Access Compliance Report

Public Rights-of-Way

(Curb Ramps)

Intersection ID: 3101	Main Street: ALABASTER_CT	Cross Street: MINERAL_RIDGE_WY	Location: E
ADA ID: F8B3C4E9AAA9	Ramp Type: Perp	Initial Pass/Fail: Fail	Overall Compliance: No
			Severity Score: 36.25

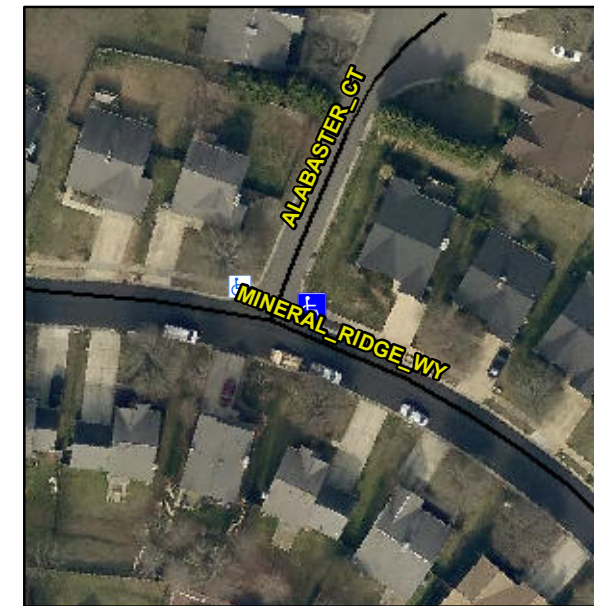
Not Found, R304.5.1, R304.5.3

Compliance	Description	Data	Compliance	Description	Data
N/A	Ramp Length (in)	94.0	Yes	Ramp Slope (%)	5.1
No	Ramp Width (in)	31.5	No	Ramp XSlope (%)	2.6
N/A	Flare Type LT	N/A	N/A	Flare Type RT	N/A
N/A	Flare Slope LT (%)	N/A	N/A	Flare Slope RT (%)	N/A
N/A	Flare Traversable LT?	N/A	N/A	Flare Traversable RT?	N/A
N/A	Landing Length (in)	N/A	N/A	DWS Provided?	N/A
N/A	Landing Width (in)	N/A	N/A	DWS Contrast?	N/A
N/A	Landing Slope (%)	N/A	N/A	DWS Length (in)	N/A
N/A	Landing X Slope (%)	N/A	N/A	DWS Full Width?	N/A
N/A	Landing Curb? (Y/N)	N/A	N/A	DWS Offset (in)	N/A
N/A	Shared Landing?	N/A			
N/A	Gutter Ponding?	N/A	N/A	Gutter Slope (%)	N/A
N/A	Gutter Lip Ht (in)	N/A	N/A	Gutter X Slope (%)	N/A
N/A	Painted X Walk1?	No	N/A	Painted X Walk2?	N/A
	X Walk 1 Direction	To NW		X Walk 2 Direction	N/A
N/A	X Walk 1 Width (in)	N/A	N/A	X Walk 2 Width (in)	N/A
	X Walk 1 Slope (%)	1.2		X Walk 2 Slope (%)	N/A
	X Walk 1 X Slope (%)	3.9		X Walk 2 X Slope (%)	N/A

Remove & Replace Entire Ramp.
